GREENVILLE UTILITIES COMMISSION
QUESTIONS AND ANSWERS II FOR RFB 26-54
FOR TRANSFORMERS
9/1/2026 @ 2:00 PM

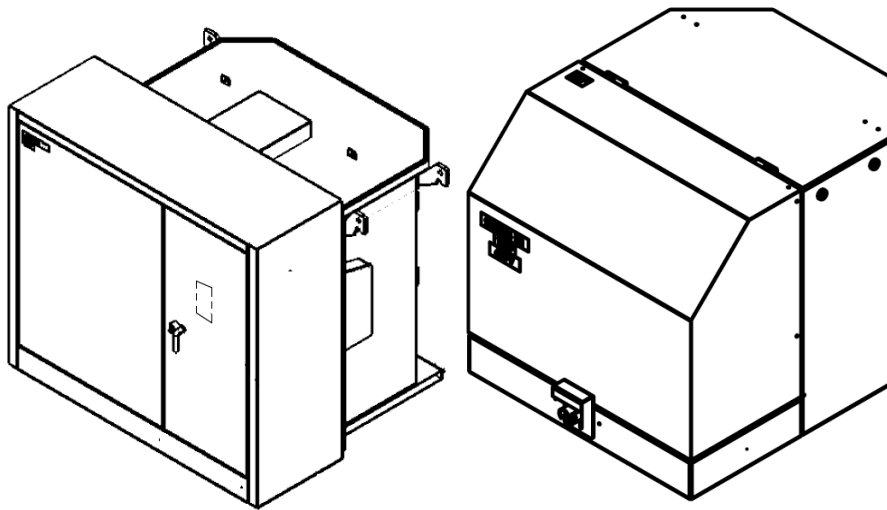
2. Are there any restrictions regarding the design of pad-mounted transformers, or is the design shown below acceptable

Please read specifications/standards and quote accordingly. Exceptions should be noted on the bid.
